CHANGE ORDER

CHANGE ORDER NO.: 8

PROJECT: PB 05-6 PBA Concourse C Gate Expansion

CONCOURSE 'C' EXPANSION
 PALM BEACH INTERNATIONAL AIRPORT
 PALM BEACH COUNTY FLORIDA

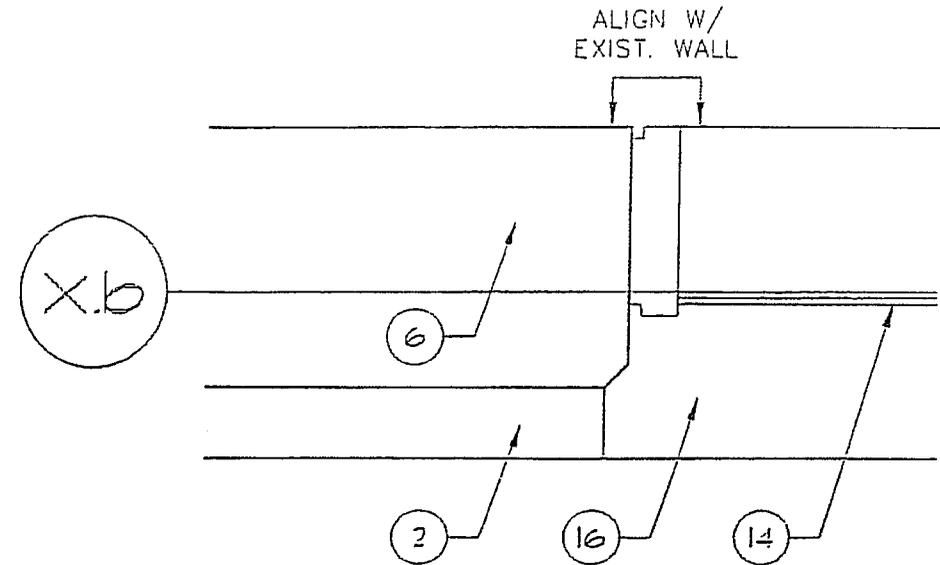
FB Description: Provide curtain wall in lieu of pre cast panels on concourse south wall

The attached sketch plans, sections, elevation and details define the revisions to the design of the new portions of the south wall of concourse 'C'.

Applicable Drawing(s): SK-A23, SK-A24, SK-S-1.01-1, SK-S-2.01-3

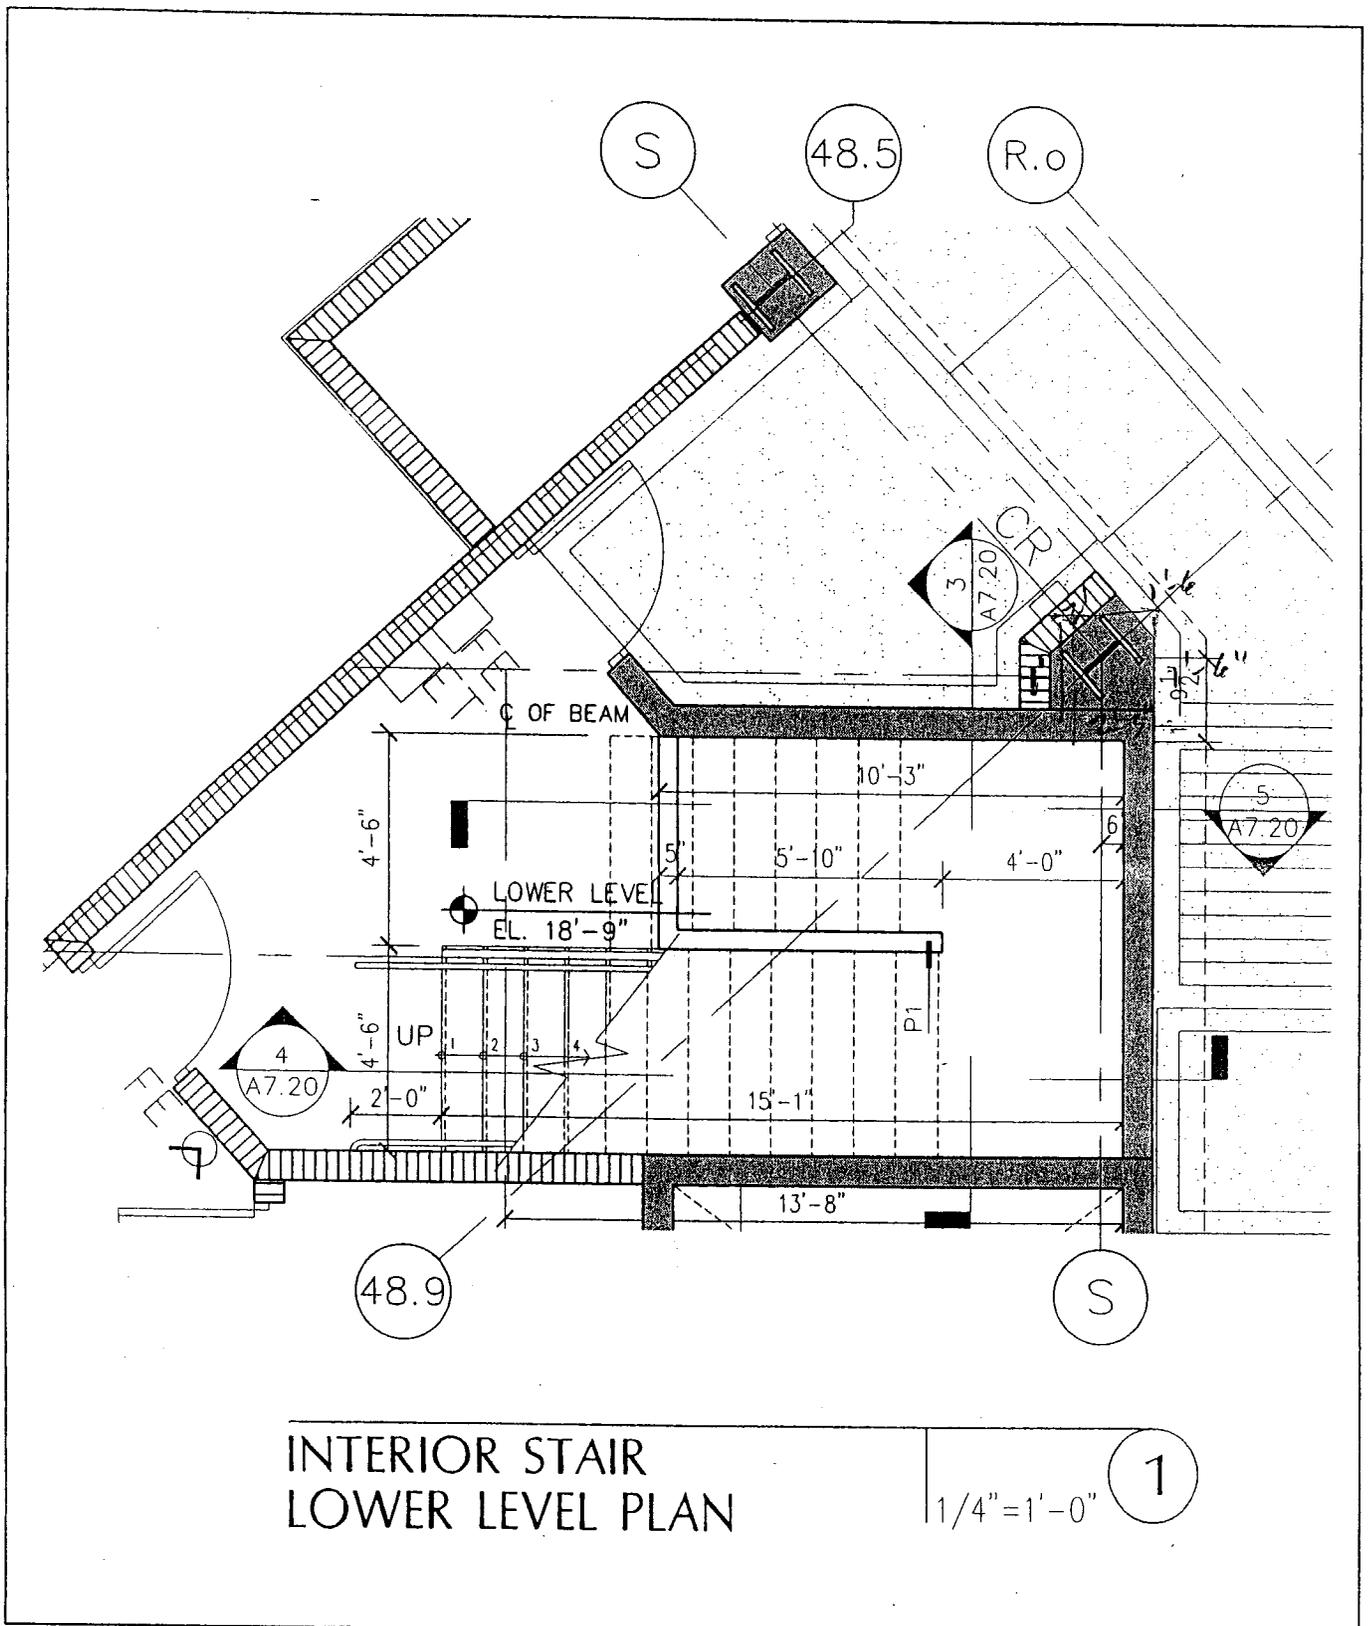
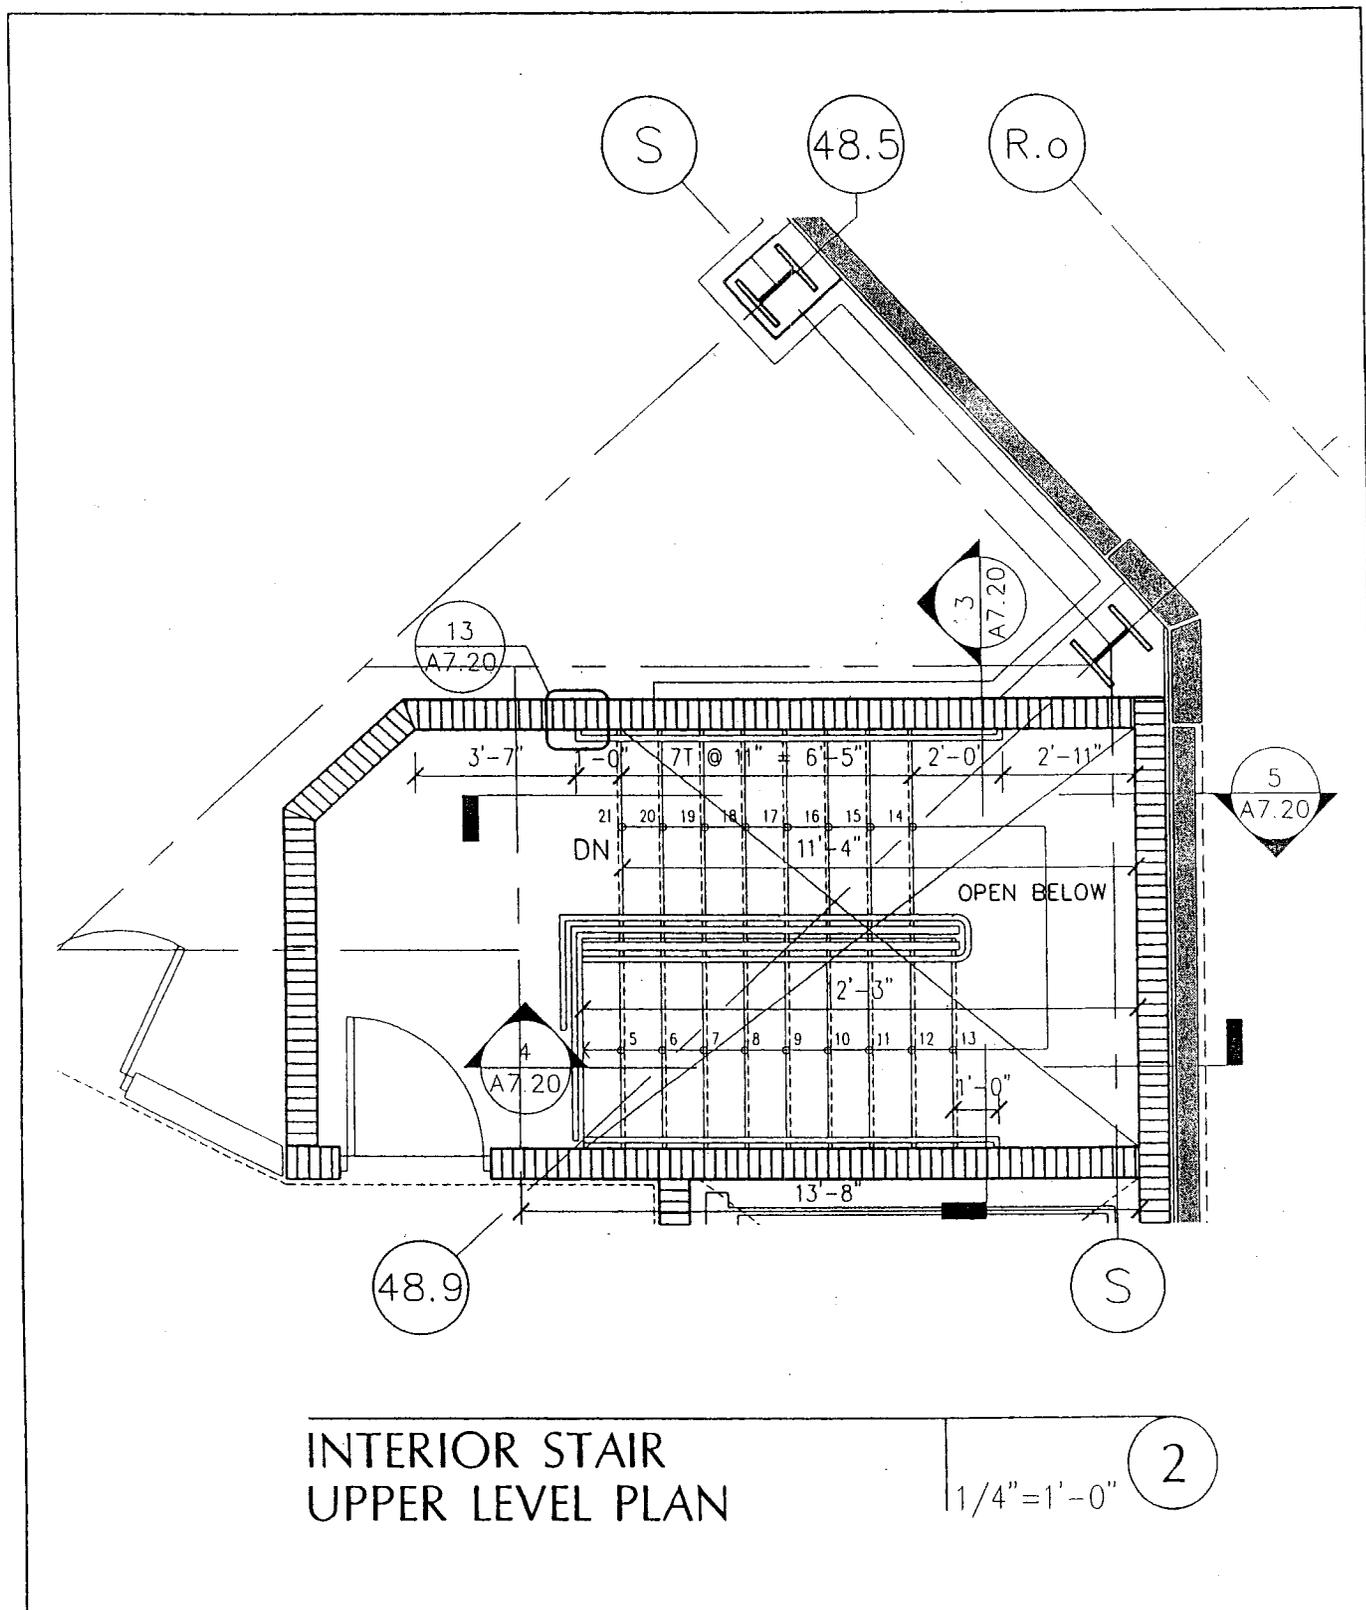
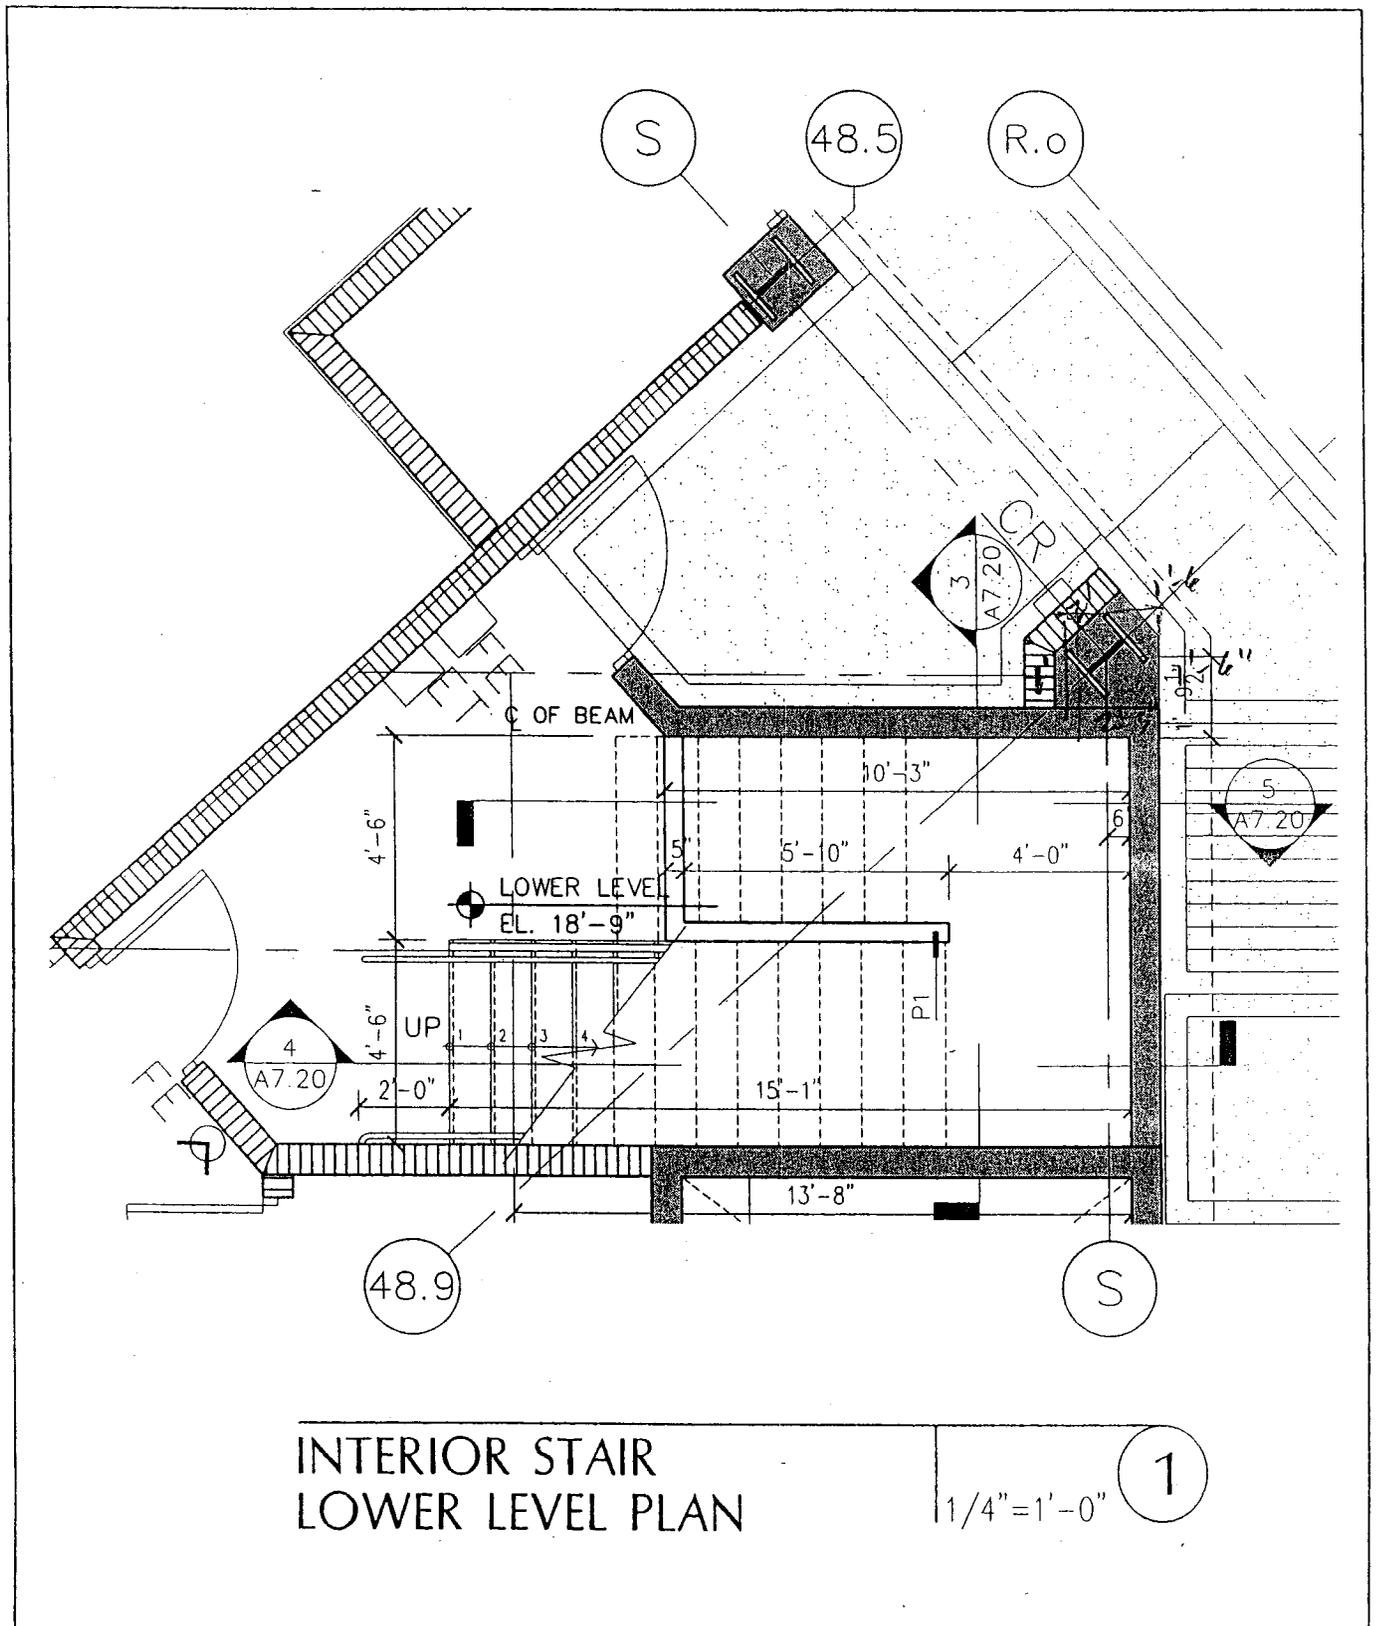
The stair configuration has been modified and riser count redistributed with more risers on the lower portion of the stair, therefore, the intermediate landing elevation has changed. In addition, door C173 and adjacent exterior wall has been shifted.

Two (2) W16 x 89 beams have been added, one to support the stair at the second level and the other to provide additional support for the block wall on the second level.

DRAWING REF. A-7.31

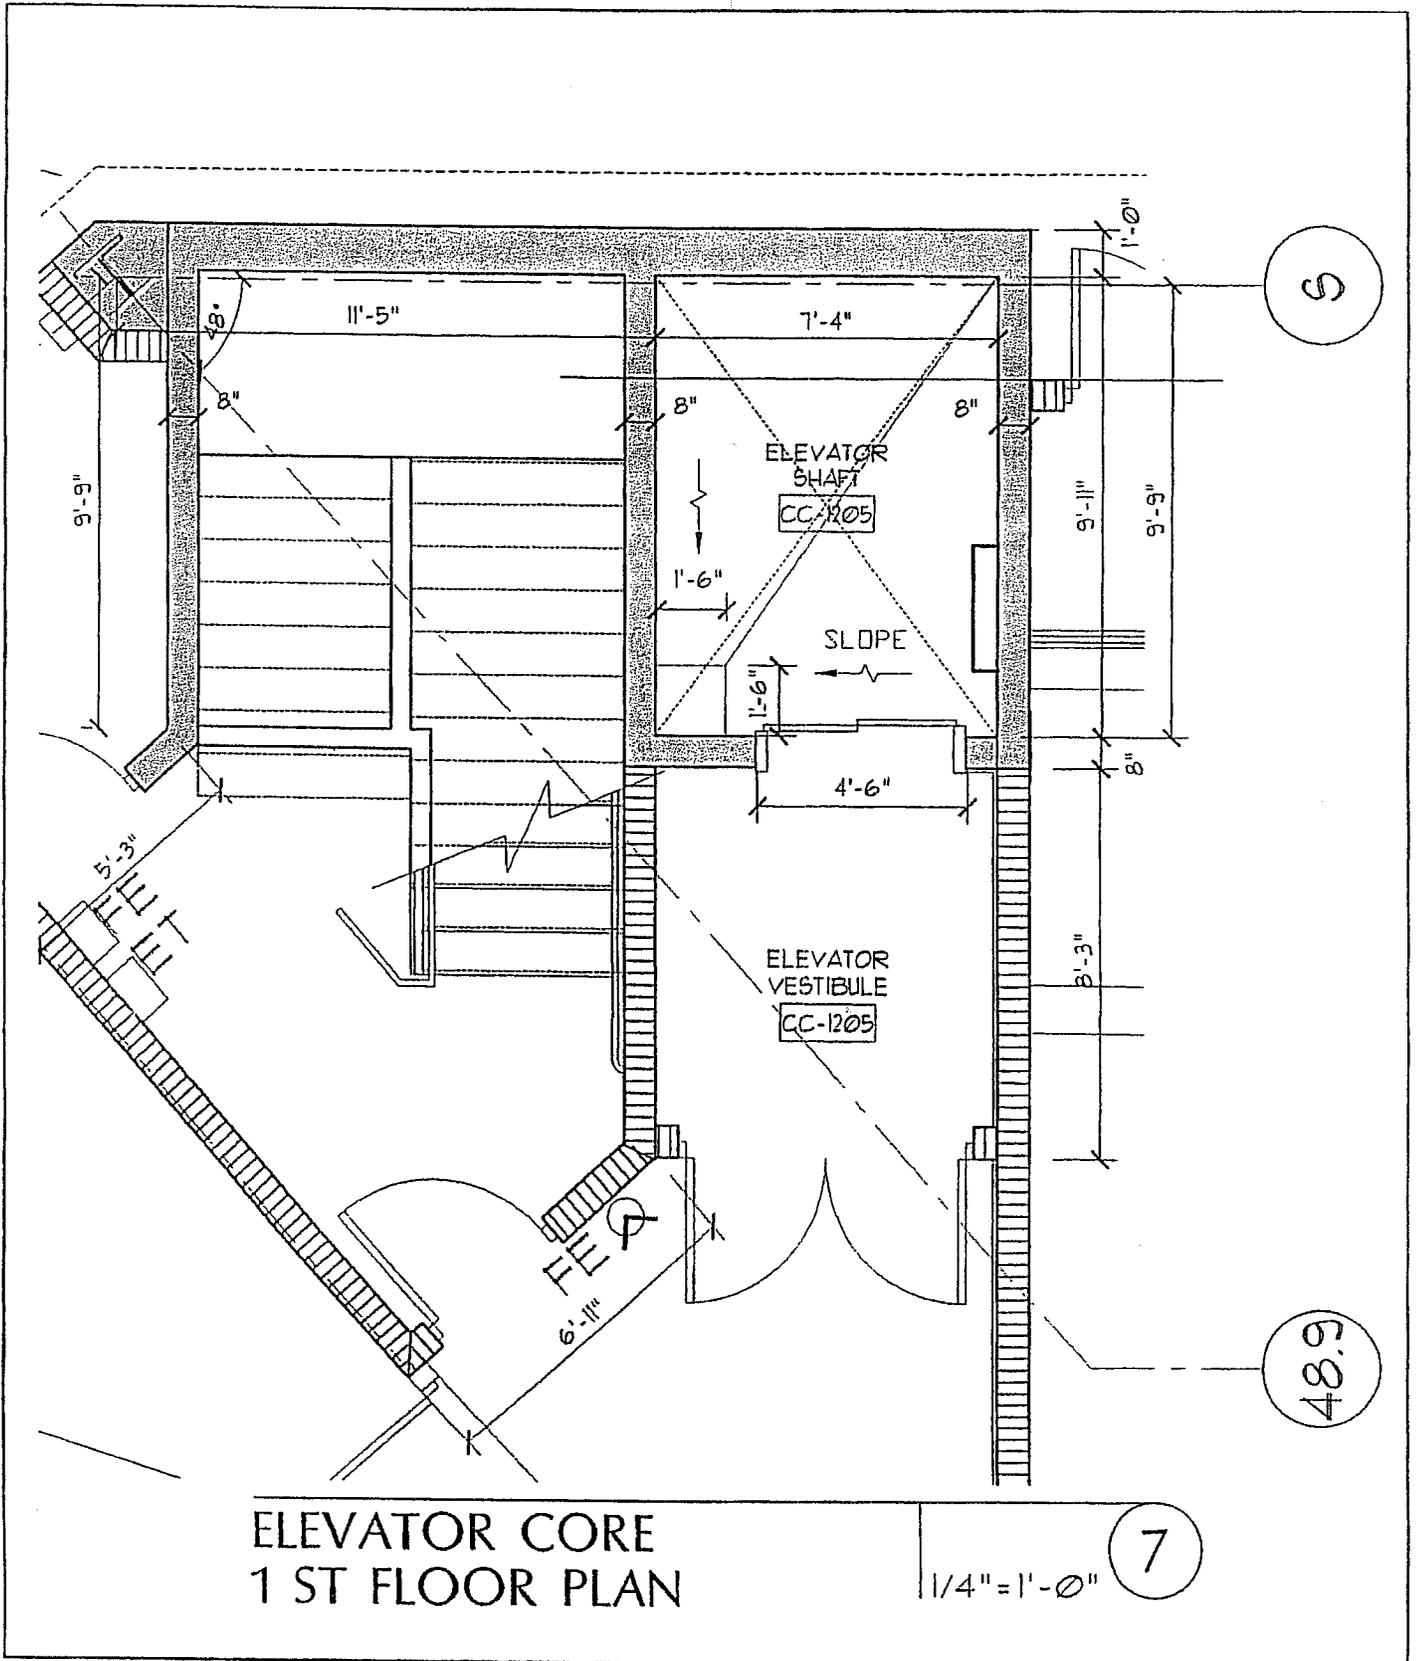
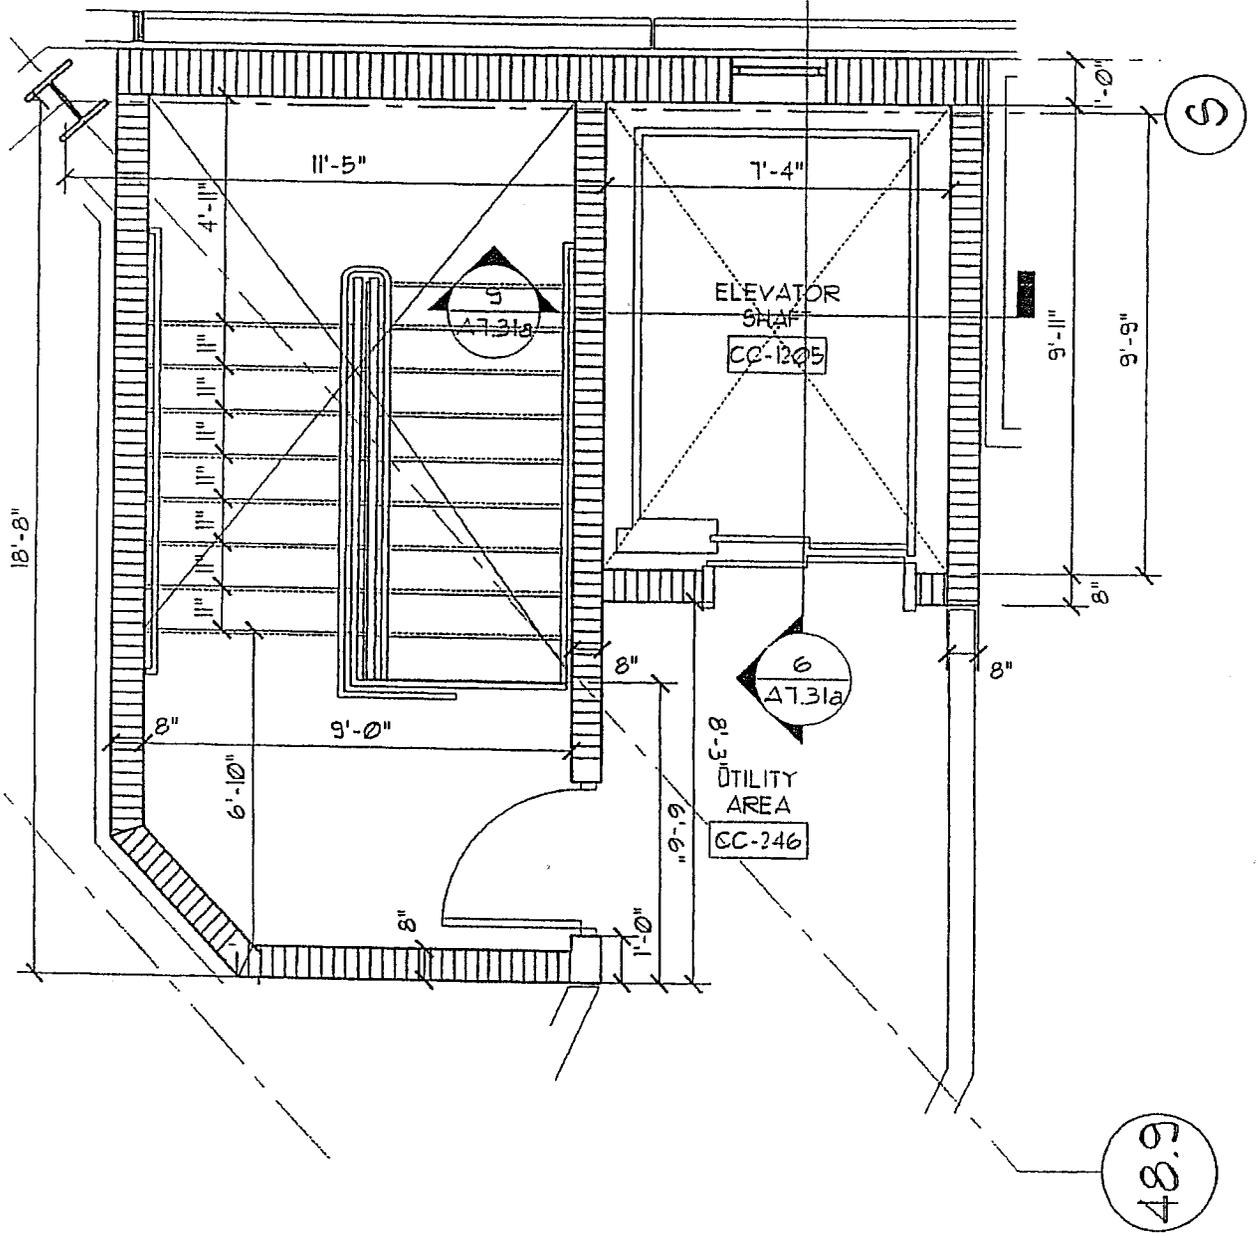
Please provide dimensions for the elevator shaft, elevator vestibule, stairs and room CC-245.
